RS-09-127
September 15, 2009

Braidwood Station, Units 1 and 2
Facility Operating License Nos. NPF-72 and NPF-77
NRC Docket Nos. STN 50-456 and STN 50-457

Byron Station, Units 1 and 2
Facility Operating License Nos. NPF-37 and NPF-66
NRC Docket Nos. STN 50-454 and STN 50-455

Subject: Revised Information Supporting License Amendment Request
Regarding Technical Specifications (TS) for Steam Generator
Permanent Alternate Repair Criteria

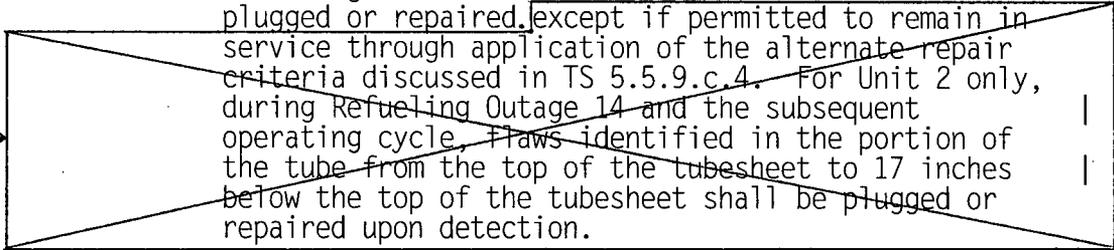
1. Tubes found by inservice inspection to contain flaws in a non-sleeved region with a depth equal to or exceeding 40% of the nominal wall thickness shall be plugged or repaired, ~~except if permitted to remain in service through application of the alternate repair criteria discussed in TS 5.5.9.c.4. For Unit 2 only, during Refueling Outage 14 and the subsequent operating cycle, flaws identified in the portion of the tube from the top of the tubesheet to 17 inches below the top of the tubesheet shall be plugged or repaired upon detection.~~

INSERT 1

The following alternate tube repair criteria shall be applied as an alternative to the 40% depth based criteria:

For Unit 2 during Refueling Outage 15 and the subsequent operating cycle, tubes with service-induced flaws located greater than 16.95 inches below the top of the tubesheet do not require plugging or repair. Tubes with service-induced flaws located in the portion of the tube from the top of the tubesheet to 16.95 inches below the top of the tubesheet shall be plugged or repaired upon detection.

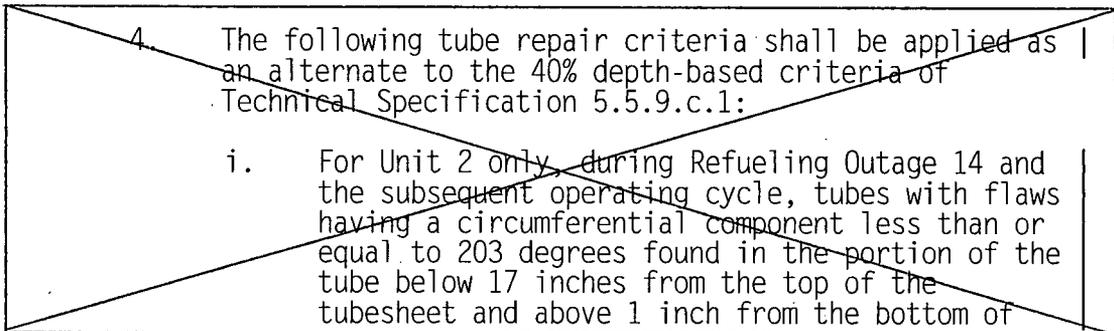
2. Sleeves found by inservice inspection to contain flaws with a depth equal to or exceeding the following percentages of the nominal sleeve wall thickness shall be plugged:
 - i. For Unit 2 only, TIG welded sleeves (per TS 5.5.9.f.2.i): 32%
3. Tubes with a flaw in a sleeve to tube joint that occurs in the sleeve or in the original tube wall of the joint shall be plugged.

4. The following tube repair criteria shall be applied as an alternate to the 40% depth-based criteria of Technical Specification 5.5.9.c.1:
 - i. For Unit 2 only, during Refueling Outage 14 and the subsequent operating cycle, tubes with flaws having a circumferential component less than or equal to 203 degrees found in the portion of the tube below 17 inches from the top of the tubesheet and above 1 inch from the bottom of

5.6.9 Steam Generator (SG) Tube Inspection Report

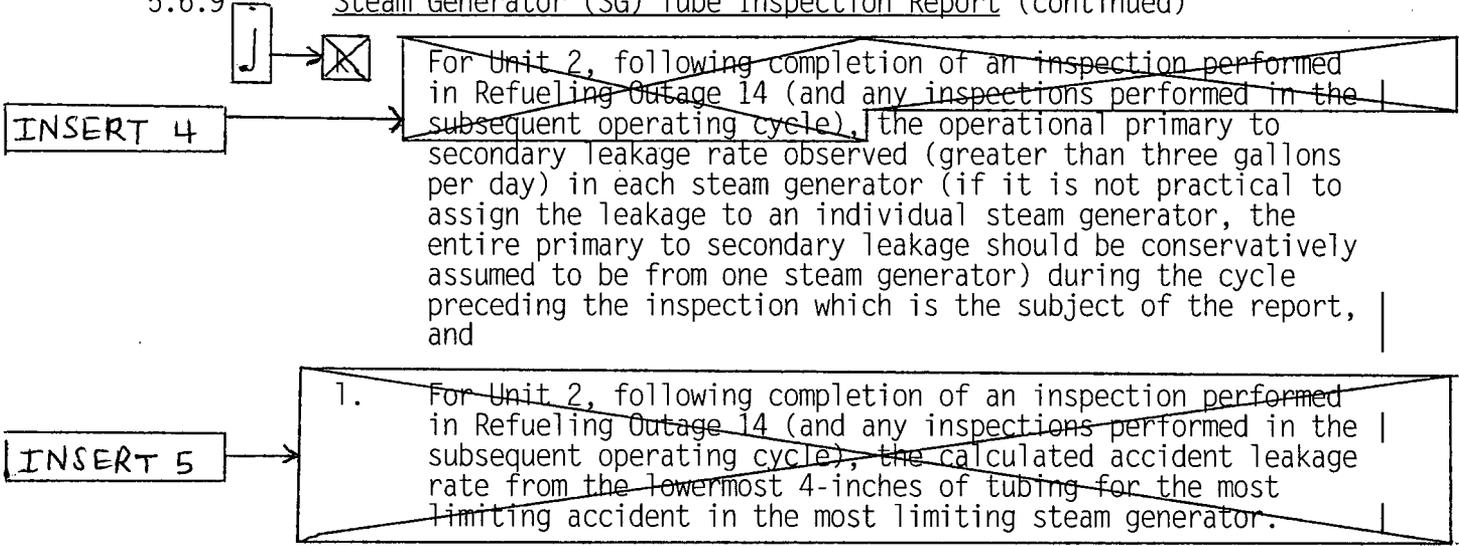
A report shall be submitted within 180 days after the initial entry into MODE 4 following completion of an inspection performed in accordance with Specification 5.5.9, Steam Generator (SG) Program. The report shall include:

- ~~j. For Unit 2, following completion of an inspection performed in Refueling Outage 14 (and any inspections performed in the subsequent operating cycle), the number of indications and location, size, orientation, and whether initiated on primary or secondary side for each service-induced flaw detected within the thickness of the tubesheet, and the total of the circumferential components and any circumferential overlap below 17 inches from the top of the tubesheet, as determined in accordance with TS 5.5.9 c.4.i,~~

INSERT 5

- k. For Unit 2 following completion of an inspection performed in Refueling Outage 15 (and any inspections performed in the subsequent operating cycle), the calculated accident induced leakage rate from the portion of the tubes below 16.95 inches from the top of the tubesheet for the most limiting accident in the most limiting SG. In addition, if the calculated accident induced leakage rate from the most limiting accident is less than 3.11 times the maximum operational primary to secondary leakage rate, the report should describe how it was determined, and

- l. For Unit 2 following completion of an inspection performed in Refueling Outage 15 (and any inspections performed in the subsequent operating cycle), the results of monitoring for tube axial displacement (slippage). If slippage is discovered, the implications of the discovery and corrective action shall be provided.
